**CITY COLLEGE OF SAN FRANCISCO**  
**OCEAN CAMPUS – A.D.A. UPGRADES AND BARRIER REMOVAL PROJECT**  
**Visual Arts, Arts Extension and Horticulture– Phase II**

**ADDENDUM NO. 2**

**DATE:** January 14, 2010

**AD2-SK-01**

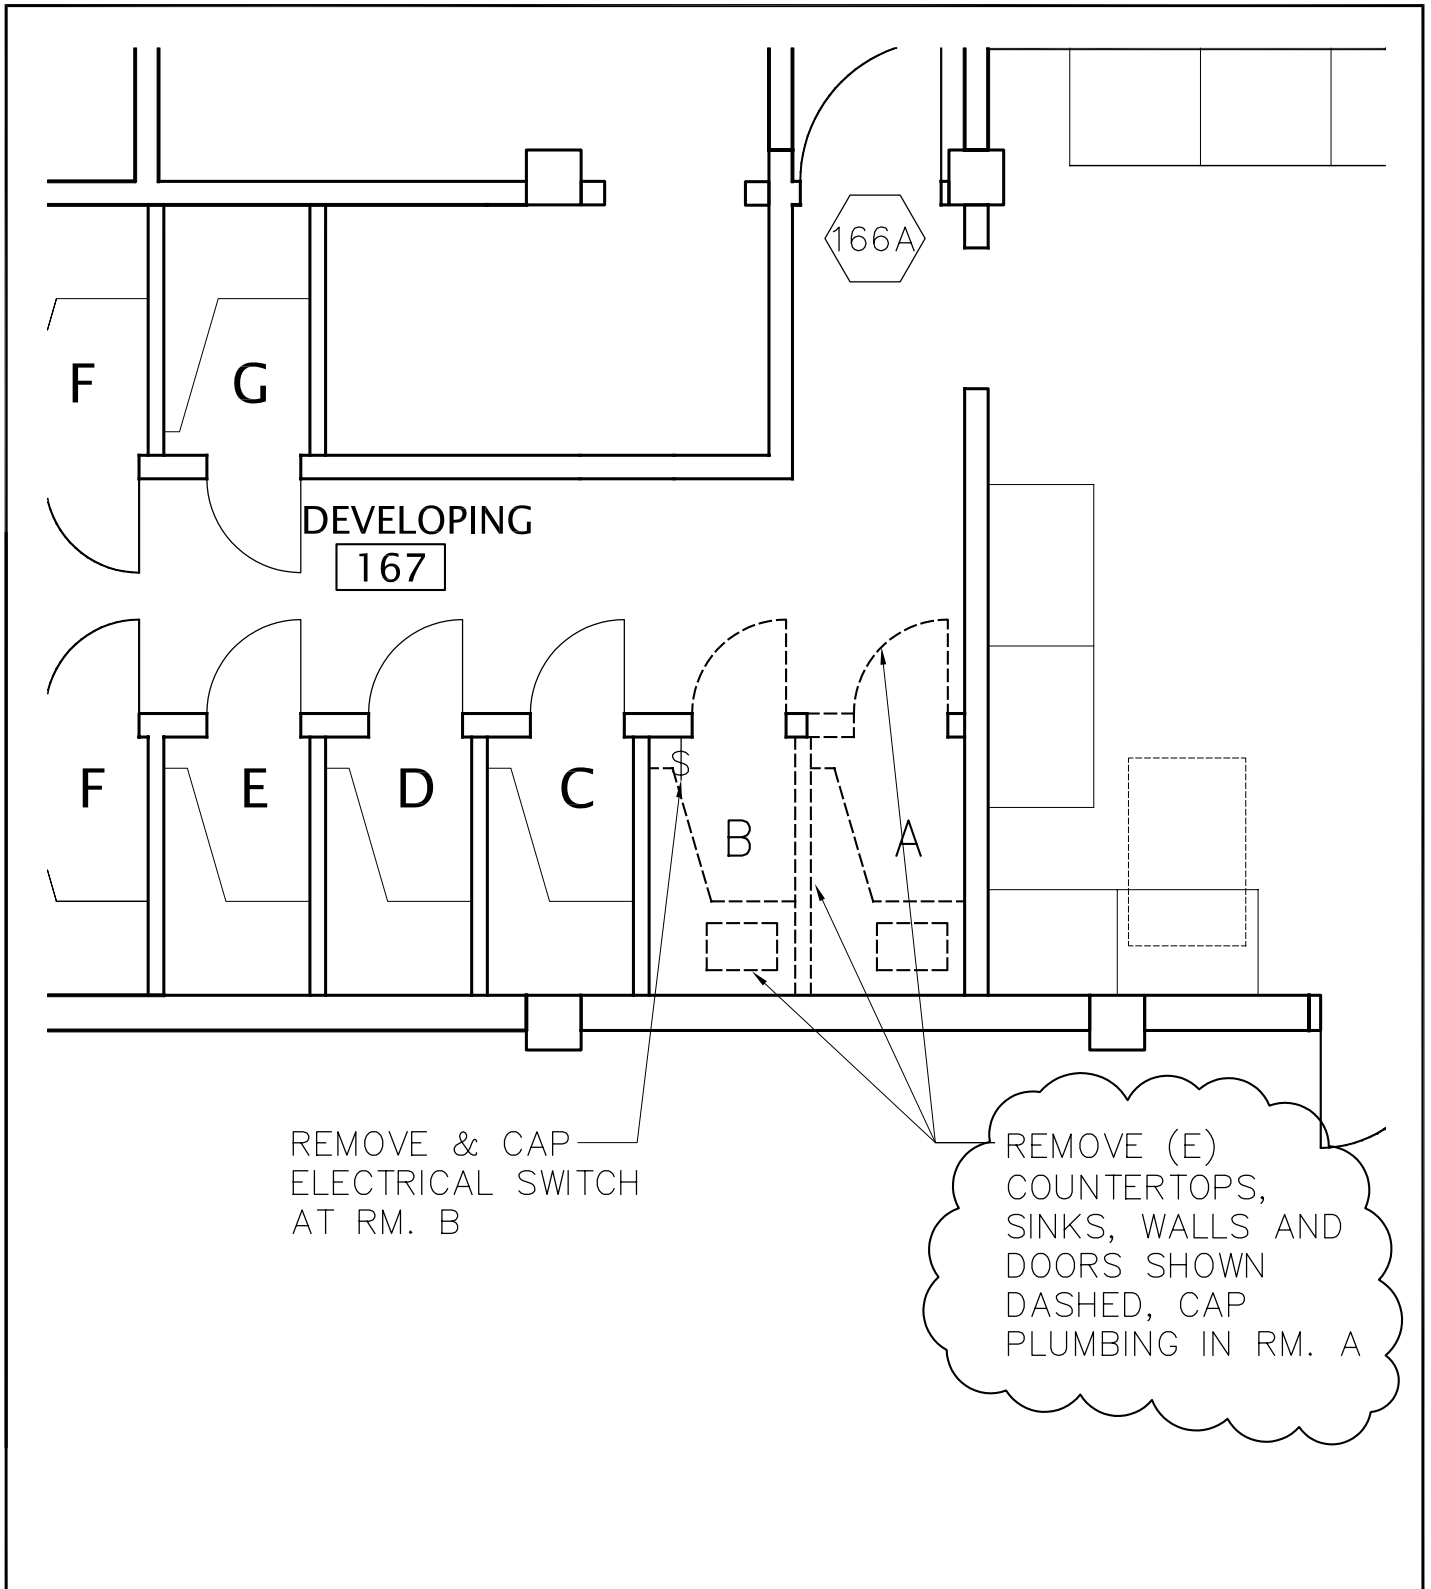
**Description:** At Developing Rm 167 A, remove (e) sink and cap plumbing per **AD2-SK-01**.

**AD2-SK-02**

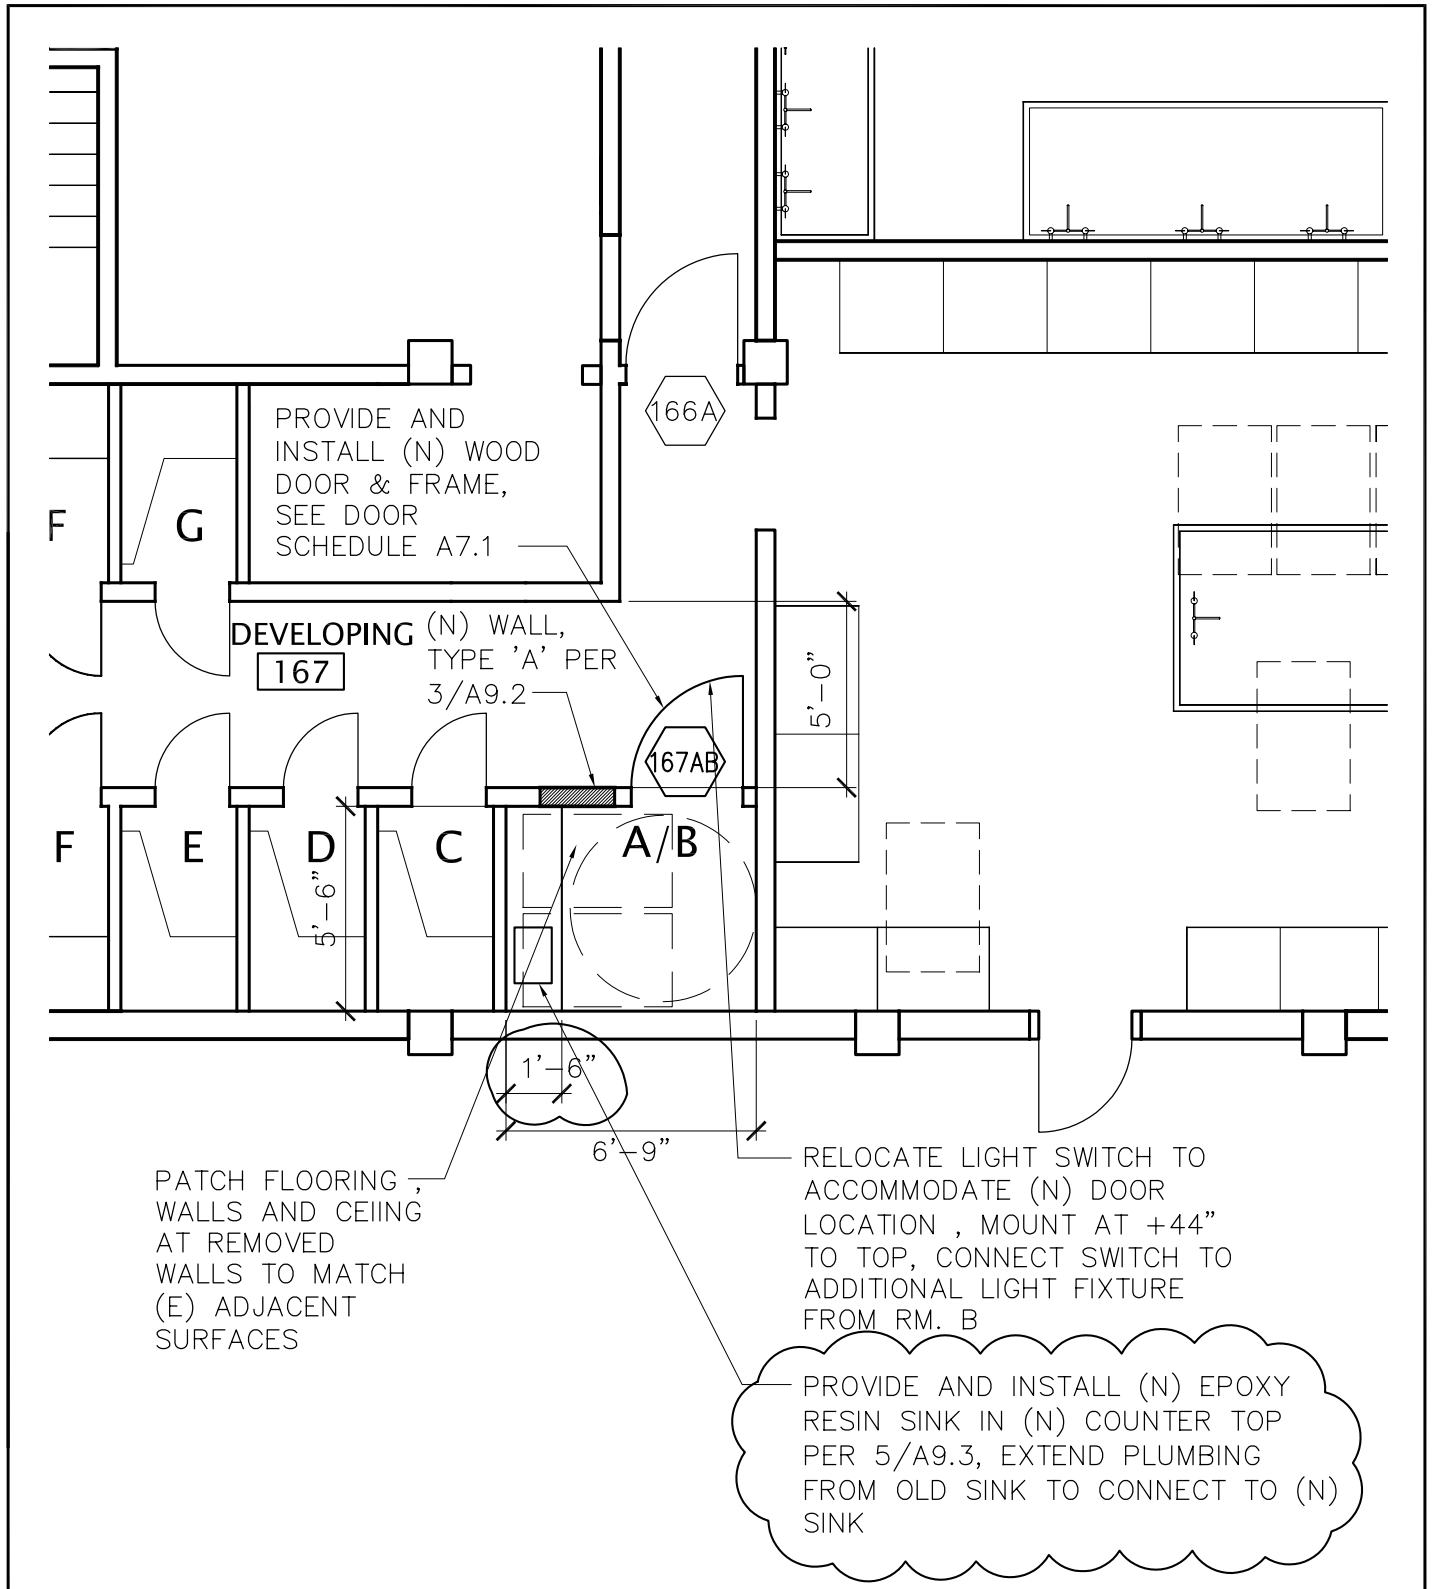
**Description:** At Developing RM 167A/B provide and install (n) epoxy resin sink at new counter top per **AD2-SK-02**.

**AD2-SK-03**

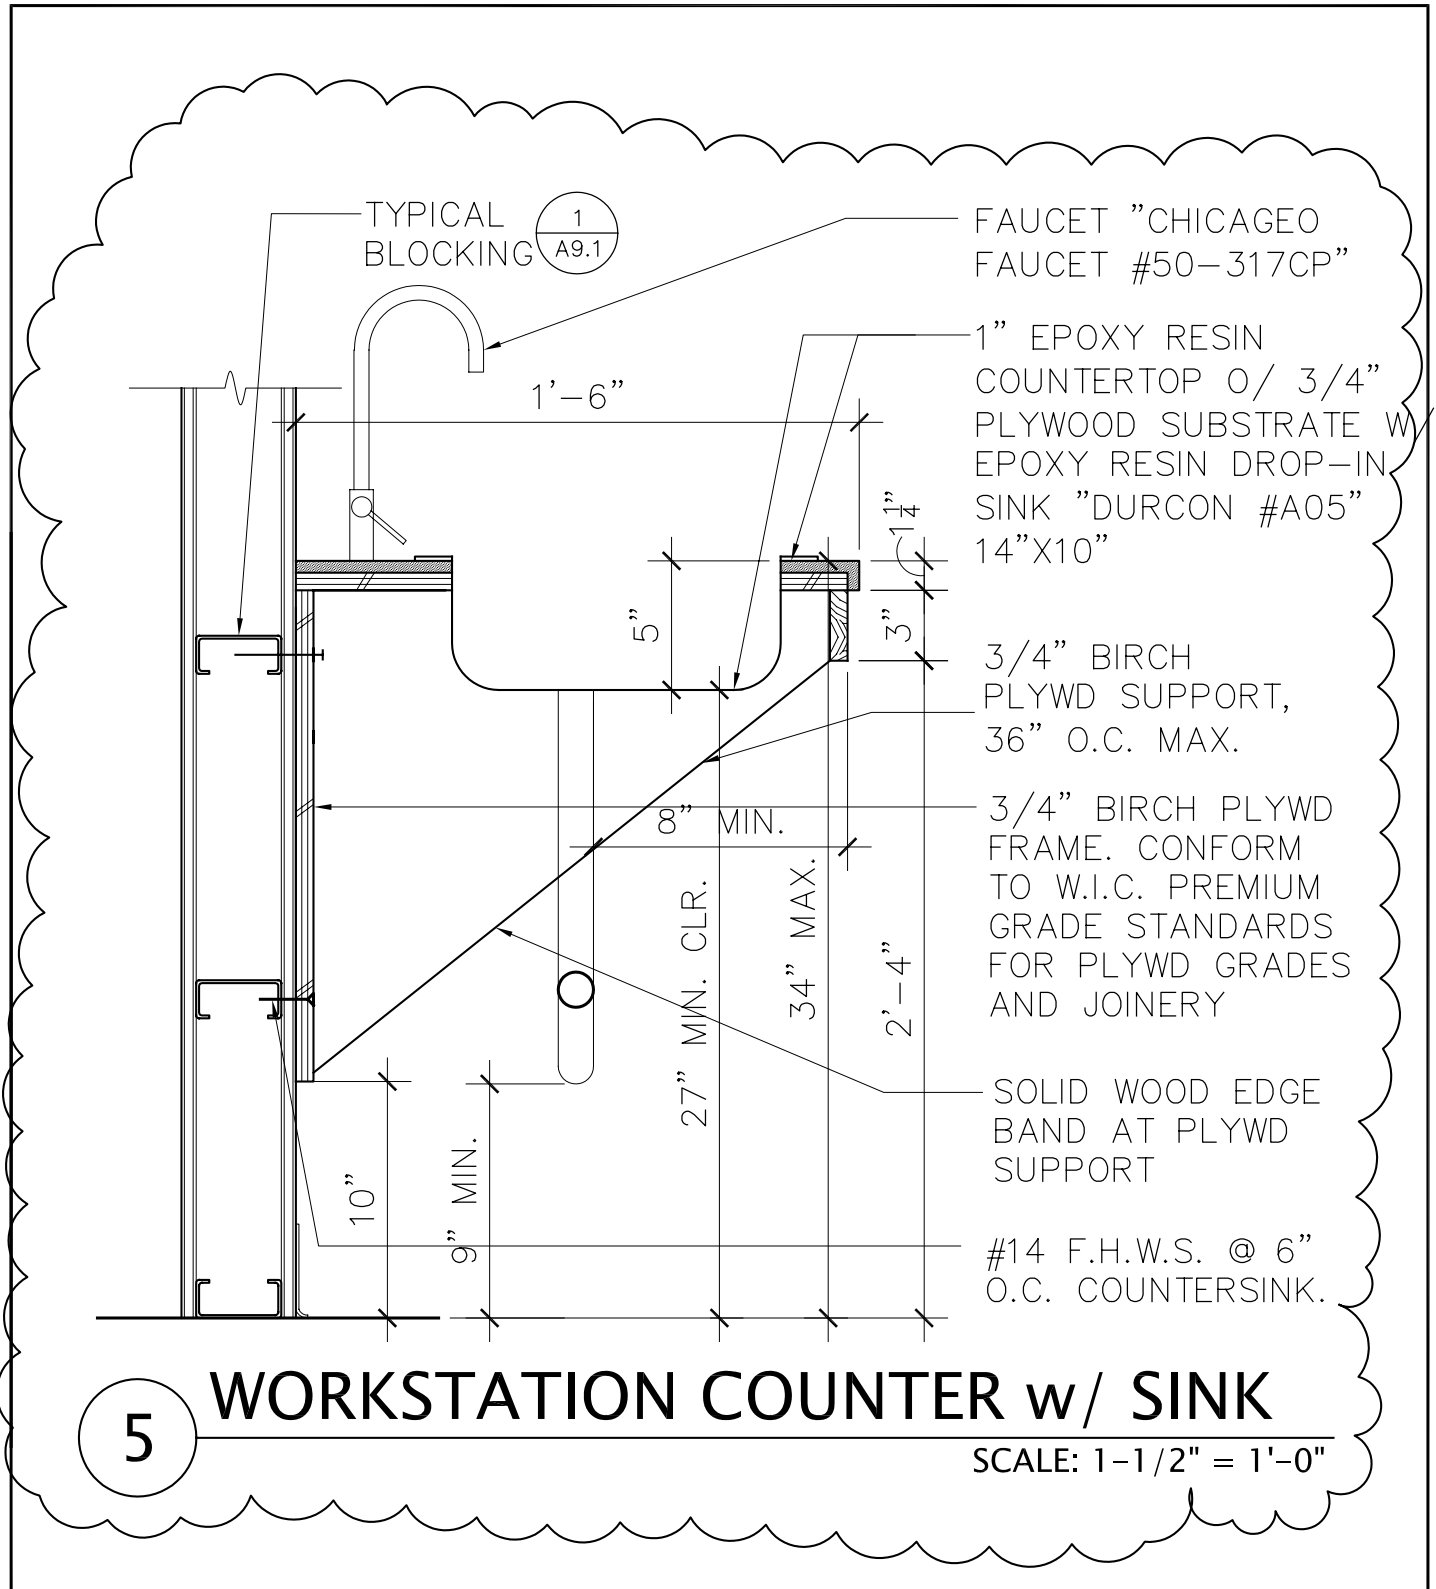
**Description:** Revise Detail 5/A9.3 to add sink to (n) workstation countertop per **AD2-SK-03**.

# AD2-SK-05

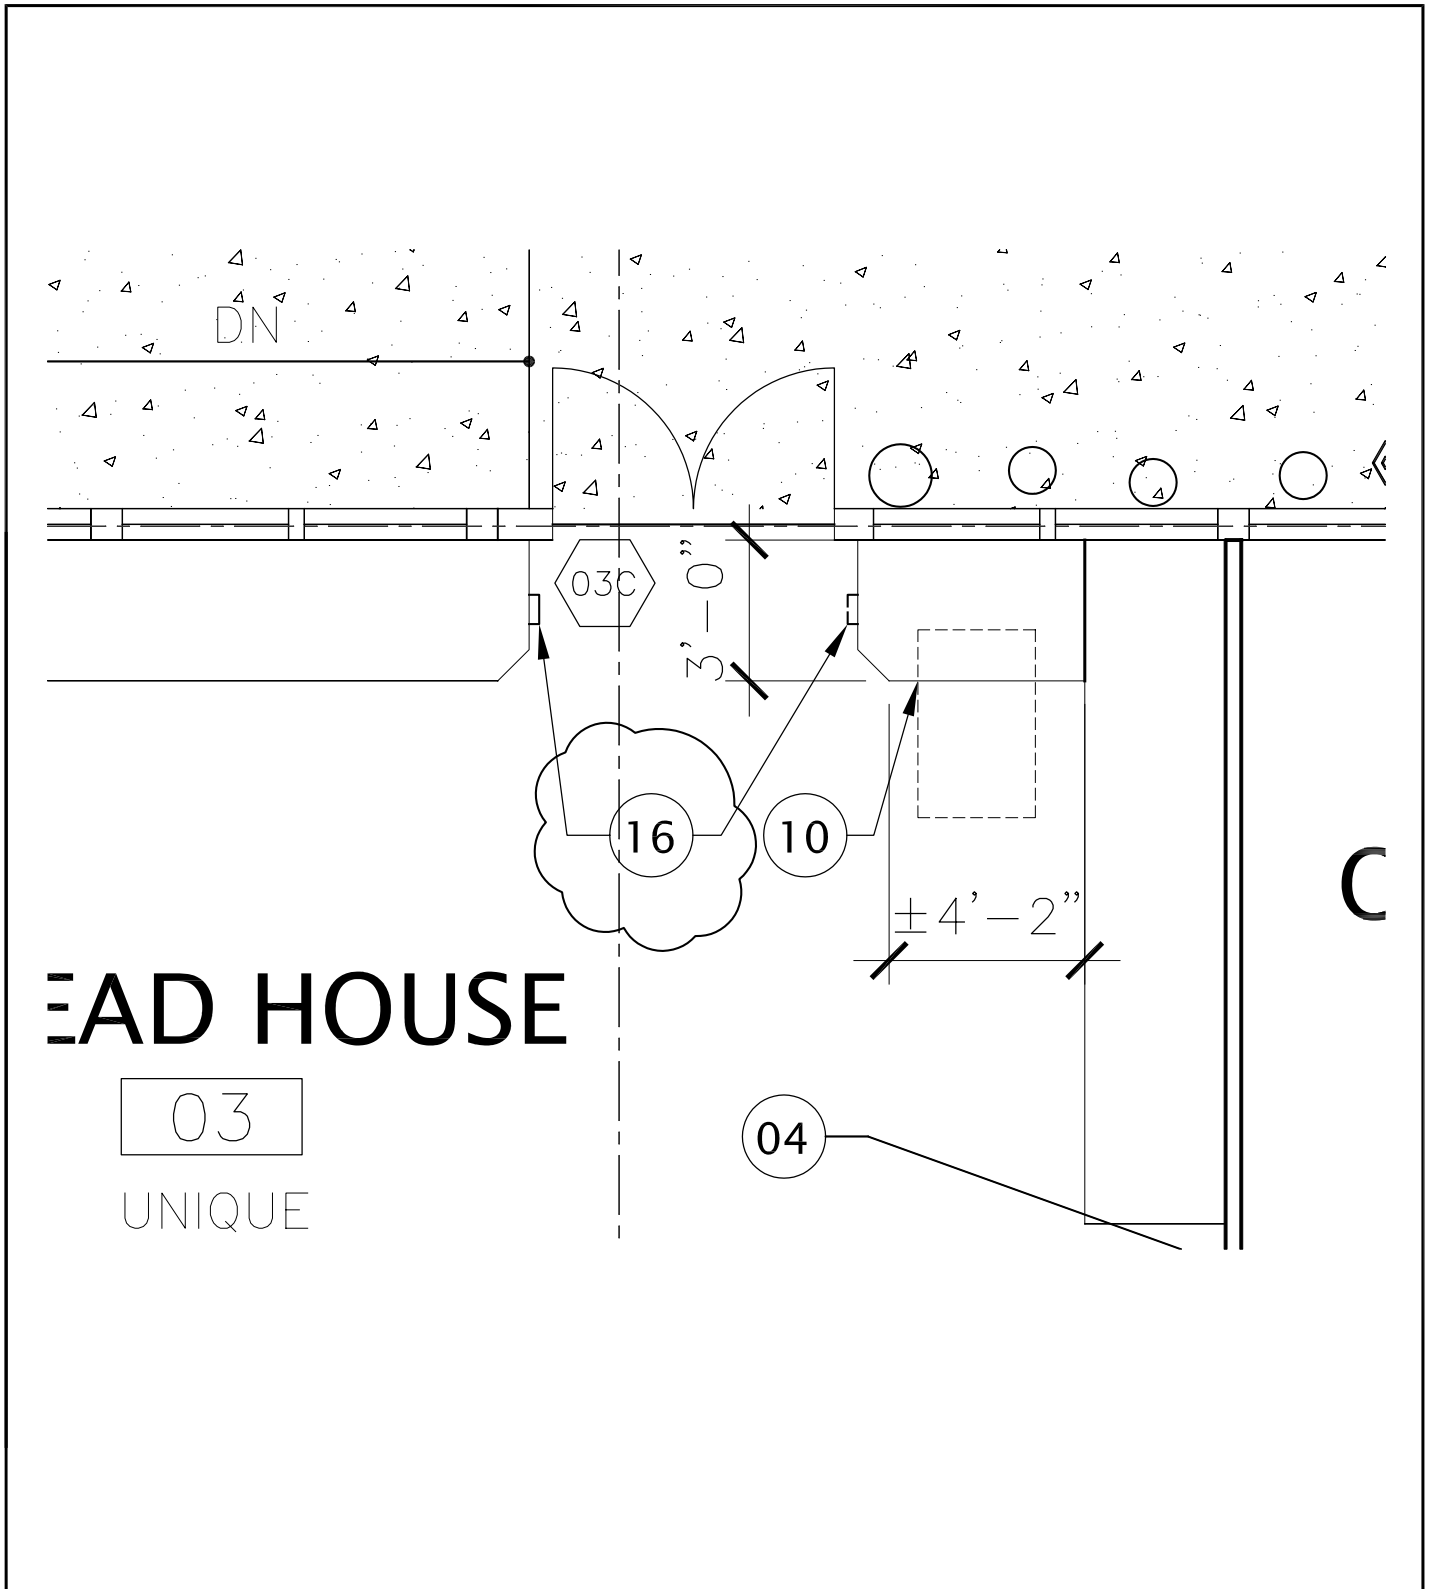
**Reference:** Arts Extensions A7.1  
**Description:** See **AD2-SK-05** for hardware group #3B.
